REZONING &

SUBDIVISION STAFF REPORT Date: October 3, 2013

SUBDIVISION NAME Storrs Manor Subdivision

LOCATION 115 Providence Street and 118 Catherine Street North

SITE PLAN

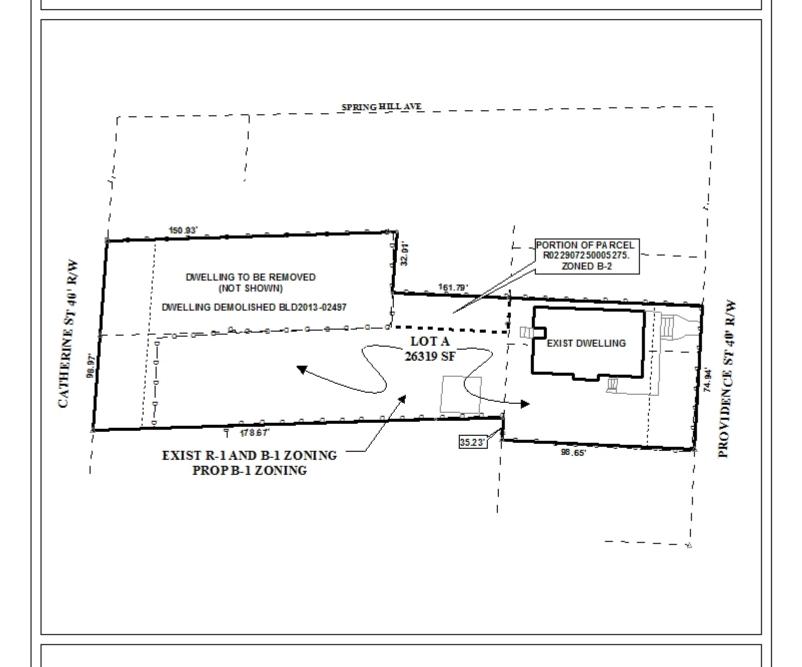
In accordance with the Subdivision Regulations, the proposed lot is compliant with the minimum size requirements. The 25-foot minimum building setback line and the lot size in square feet are illustrated on the preliminary plat and should be retained on the Final Plat, if approved.

The site has frontage along Providence Street and Catherine St, both minor streets with curb and gutter. The preliminary plat illustrates a 40' right-of-way for both streets; however, Section V.B.14. of the Subdivision Regulations requires minor streets with curb and gutter to have a minimum right-of-way of 50 feet. As a result, the applicant should provide dedication to provide 25 feet as measured from the centerline of both Providence and Catherine Streets. The lot size information and 25' setback line should be revised on the Final Plat, if approved.

The site currently has one curb-cut along Providence Street and one curb-cut along Catherine Street. As a means of access management, a note should be placed on the Final Plat limiting the site to the existing curb-cuts, with any changes to the size, design or location to be approved by Traffic Engineering and conform to AASHTO standards.

It should be pointed out that the proposed Lot A is considered a double frontage lot as a result of frontage along both Providence and North Catherine Streets and, as such, would require a waiver of Section V.D.8. of the Subdivision Regulations for approval. Also, the site has 2 existing curb-cuts, one to North Catherine Street and one to Providence Street. As a means of access management, the proposed lot should be limited to only one curb-cut, to either street, to be chosen by the applicant, with any changes to the size, design or location to be approved by Traffic Engineering and conform to AASHTO standards.

It should also be pointed out that when this request first appeared before the Planning Commission at its October 3, 2013 meeting, Staff originally favored dedication sufficient to provide 25' along the frontages of both North Catherine and Providence Streets, as measured from the centerline. Since that time, Staff now favors a 50' minimum building setback in lieu of dedication. If approved, the Final Plat and site plan should be revised to depict a 50' minimum building setback line along both street frontages.

- 1) Illustration of a 50' minimum building setback line, as measured from the centerline, on the Final Plat along Providence and North Catherine Streets;
- 2) Retention of the lot size in square feet and acres on the Final Plat;
- 3) Placement of a note on the Final Plat stating: (Lot A should be limited to one curb-cut, to either street, to be chosen by the applicant, with any changes to the size, design or location to be approved by Traffic Engineering and conform to AASHTO standards.);
- 4) Placement of a note on the Final Plat stating: (Development of the site must be undertaken in compliance with all local, state and Federal regulations regarding endangered, threatened or otherwise protected species.);
- 5) Compliance with Engineering comments: (The following comments should be addressed prior to acceptance and signature by the City Engineer: a. Provide all of the required
